BIDDER'S SUBMITTAL

Company: Tobo Construction Inc.

**PROPOSAL, SPECIFICATIONS, BOND AND AFFIDAVIT FOR CONSTRUCTION OF THE
TORRANCE TRANSIT PARK AND RIDE REGIONAL TERMINAL, FEAP 764
B2017-39**

- 2) Reference part of Drawing Sheet EY600 (see next page).

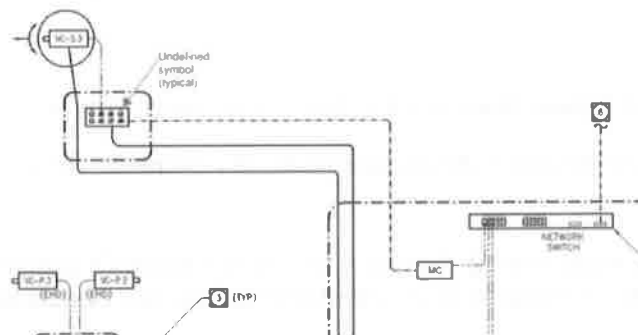
There is an undefined symbol on the single line drawing. Is this a hardened network switch? Is it to be provided by the City IT (like the other network hardware)?

A6b: The referenced device in the drawing attached to the Bidder's RFI (partial, marked up portion of plan shown above) is a hardened outdoor rated switch. It is specified in Section 282300, Article 2.2, Paragraph B.
